CBD & SOUTH EAST LIGHT RAIL PROJECT

(RANDWICK CITY COUNCIL & UNSW AREA)

TECHNICAL REVIEW – TRAFFIC ENGINEERING & ROAD SAFETY (DECEMBER 2013)

Figure 22: Nineways – Proposed Conditions

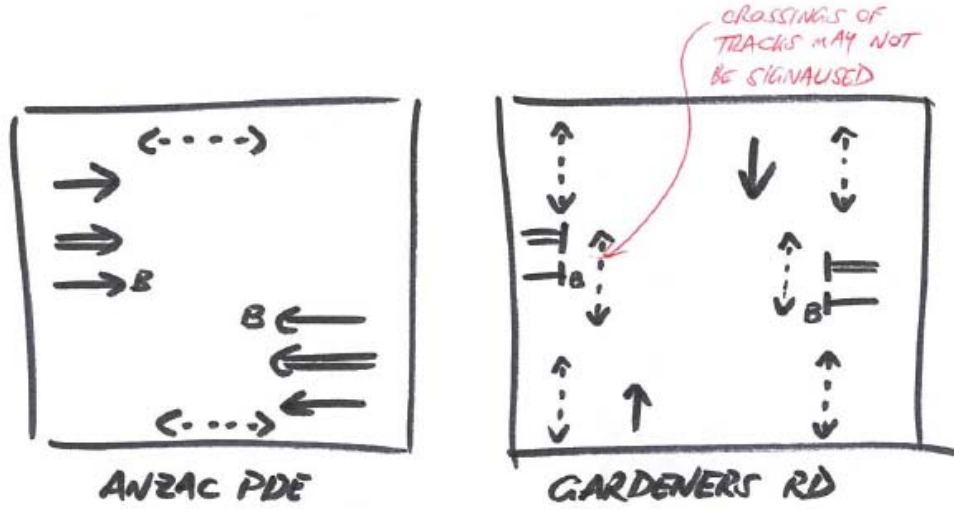
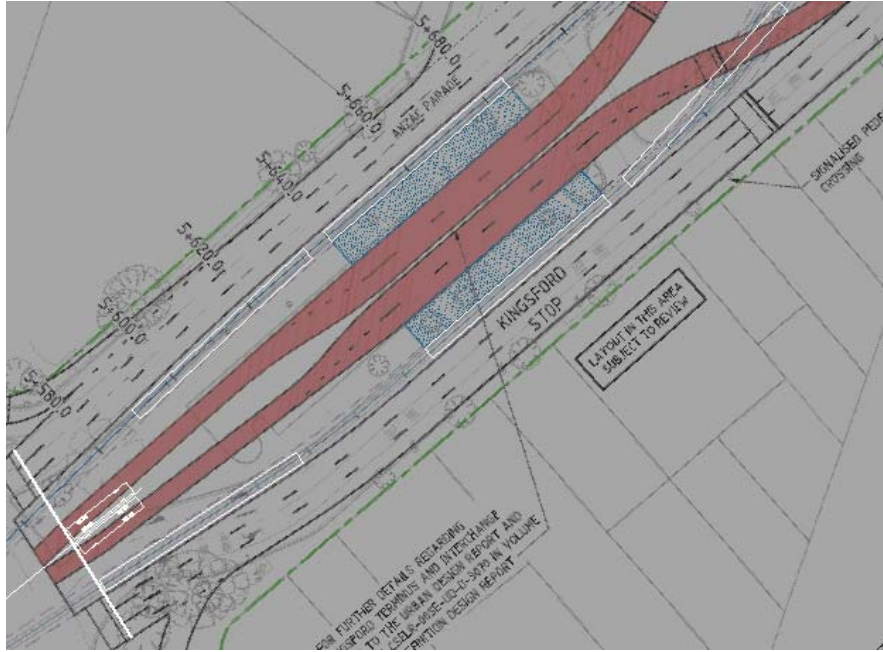
Category	Sub-Category	Proposed Conditions	Issue / Comment	Potential Alternative / Mitigating Measure
Consistency	-	-	The 'Road Engineering' plans and the 'Stop Plans' show different configurations for the pedestrian crossings. It has been assumed that the Stop Plans are the basis for comment.	Update plans to be consistent.
Location	Surrounding Land Uses	Intersection located at southern end of Kingsford commercial area. Signalised cross intersection at Nineways.	Safe pedestrian access around the commercial area and to / from the stops will be improved with the replacement of the roundabout with a signalised cross intersection at Nineways.	Nil.
	Land Acquisition	-	Nil.	Nil.
Layout	Platform Size	-	Nil.	Nil.
	Storage	No pedestrian storage provided between traffic lanes and light rail tracks. No designated area for buses on north side of intersection.	No room between road and tracks for pedestrians to store. This means that it will be more difficult to provide additional priority phases for LRV / buses as pedestrians will need to cross traffic lanes and tracks in one movement. Pedestrian push buttons would need to be provided on the inside of the tracks and there would be no room for signal pedestals between the tracks and the traffic lanes (which are a good way of 'separating' the traffic and LRV / bus movements). At most other locations, these types of crossings will be LRV priority crossings. All pedestrians on the north side of the intersection will be crossing the full width of Anzac Parade. The provision of separate lanes for buses to travel through the Nineways intersection (as provided on the south side only) could improve the priority for buses and LRV. Northbound vehicles could travel through the intersection together and then merge on the north side. Alternatively, northbound vehicles could be given separate phases to travel through the intersection. 	Review layout of Nineways intersection to create pedestrian storage areas between the traffic lanes and the light rail tracks. Review layout of Nineways intersection to create bus lanes on the north side of the intersection.

Swept Paths	-	n/a	n/a
	LRV	-	Southbound 45m long LRV will block access to potential bus lane on the inside of the light rail tracks. There is sufficient length for second southbound LRV to cross intersection and wait before entering stop.	Nil.
	Signal Pedestals	-	There is no room available for signal pedestals to be located between the traffic lanes and the light rail tracks. Large mast arms will be required. The height and location of the large mast arms will need to consider the overhead light rail wires. Signal phasing for the LRV and bus priority will be complex, with requirements for separate lanterns for each of the movements. Creation of a pedestrian storage area between the light rail tracks and the traffic lanes would create space for traffic signal pedestals for pedestrians, traffic, LRV and buses.	Review layout of Nineways intersection to create pedestrian storage areas between the traffic lanes and the light rail tracks.

Traffic Lanes	Southbound – 2 through & 1 right turn. Northbound – 3 through.	The layout at the intersection is significantly different in each direction. Southbound:	Update plans to reflect proposed lane configuration.

Category	Sub-Category	Proposed Conditions	Issue / Comment	Potential Alternative / Mitigating Measure
			<p>There is a left turn slip lane, two through lanes (one 30m short lane) and a right turn lane on the approach. There are three through lanes on the departure. It is assumed that the right turn arrows are incorrect and no right turn is proposed.</p> <p>Northbound:</p> <p>There is a left turn slip lane and three through lanes on the approach. There are three through lanes on the departure.</p>	
Access	Crossing Points	Signalised cross intersection, crosswalks across all legs and left turn slip lanes.	Layout provides safe access around intersection except for crossings of the light rail tracks and bus lanes. It is unclear how these will operate with respect to pedestrian movements.	Review layout of Nineways intersection to provide safe pedestrian access across bus lanes and light rail tracks.

Ramps	-	Nil.	Nil.
	Illegal Access	-	Signalised crossings are provided for all movements so there should be minimal illegal crossings. However, illegal crossings will occur if the crossings of the light rail tracks and bus lanes are signalised.	Nil.
	Safety	-	Illegal access is the main safety issue as discussed above.	Nil.
	Footpath / Shared Path	-	Due to the ramp configuration between the stops, it is expected that the majority of pedestrians coming from the Nineways intersection will access their stop from the Nineways intersection (rather than use the internal ramps).	Nil.
	Vehicle	-	No right turns permitted from Anzac Parade (it is assumed southbound right turn incorrectly shown on plans).	Nil.
Intermodal	Sharing of Tracks	Buses to shared light rail tracks to north of intersection.	As discussed above, review layout for LRV and buses through intersection.	Nil.
	Bus Stops	-	Nil.	Nil.
	Bus / LRV Transfer	-	Nil.	Nil.

Bus Priority	Buses to shared light rail tracks to north of intersection.	As discussed above, review layout for LRV and buses through intersection.	Nil.
Signal Operation	Overview	-	<p>Only east/west through traffic movements (and potentially east/west pedestrians) will conflict with north/south LRV and bus movements. Should be able to introduce relatively easy phasing with advance detection from the Pedestrian Operated Signals to the north and the stop from the south. If pedestrian crossings are set up as LRV priority, then the priority for LRV and bus should work effectively. The main restriction to priority for north/south LRV and buses will be the crossing time required for pedestrians crossing Anzac Parade i.e. even if a LRV is detected on approach, the signals need to wait until the appropriate walk time and clearance time has finished.</p> 	Review pedestrian crossings of central median – signalised or LRV priority.
